Access Compliance Report

Public Rights-of-Way

(Curb Ramps)

Intersection ID: 14431	Main Street: N_COLONIAL_AV	Cross Street: RANDOLPH_RD	Location: NE
ADA ID: 646A9508DD81	Ramp Type: Perp	Initial Pass/Fail: Fail	Overall Compliance: No
Codes/Mitigation Info/Possible Solution		Field Measurements/Component Compliance	
Severity Score: 33.75

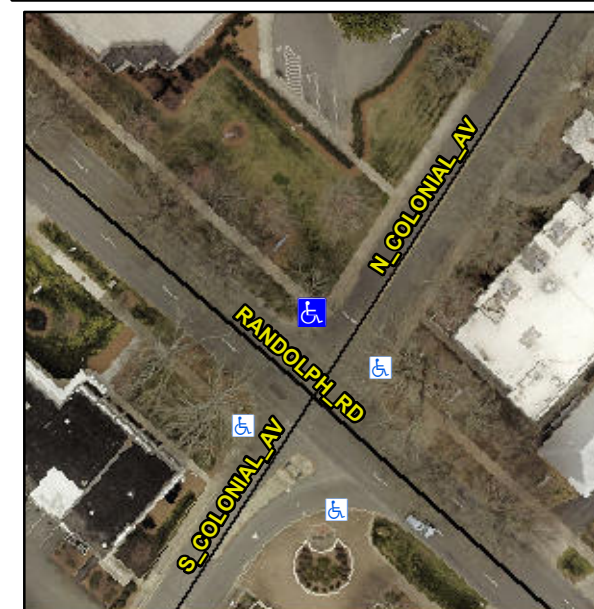
R304.5.1, R304.2.2

Compliance	Description	Data	Compliance	Description	Data
N/A	Ramp Length (in)	83.0	No	Ramp Slope (%)	14.5
No	Ramp Width (in)	38.0	Yes	Ramp XSlope (%)	1.2
N/A	Flare Type LT	N/A	N/A	Flare Type RT	N/A
N/A	Flare Slope LT (%)	N/A	N/A	Flare Slope RT (%)	N/A
N/A	Flare Traversable LT?	N/A	N/A	Flare Traversable RT?	N/A
N/A	Landing Length (in)	N/A	N/A	DWS Provided?	N/A
N/A	Landing Width (in)	N/A	N/A	DWS Contrast?	N/A
N/A	Landing Slope (%)	N/A	N/A	DWS Length (in)	N/A
N/A	Landing X Slope (%)	N/A	N/A	DWS Full Width?	N/A
N/A	Landing Curb? (Y/N)	N/A	N/A	DWS Offset (in)	N/A
N/A	Shared Landing?	N/A			
N/A	Gutter Ponding?	N/A	N/A	Gutter Slope (%)	N/A
N/A	Gutter Lip Ht (in)	N/A	N/A	Gutter X Slope (%)	N/A
N/A	Painted X Walk1?	No	N/A	Painted X Walk2?	N/A
	X Walk 1 Direction	To SE		X Walk 2 Direction	N/A
N/A	X Walk 1 Width (in)	N/A	N/A	X Walk 2 Width (in)	N/A
	X Walk 1 Slope (%)	4.0		X Walk 2 Slope (%)	N/A
	X Walk 1 X Slope (%)	1.3		X Walk 2 X Slope (%)	N/A

Remove & Replace Entire Ramp.
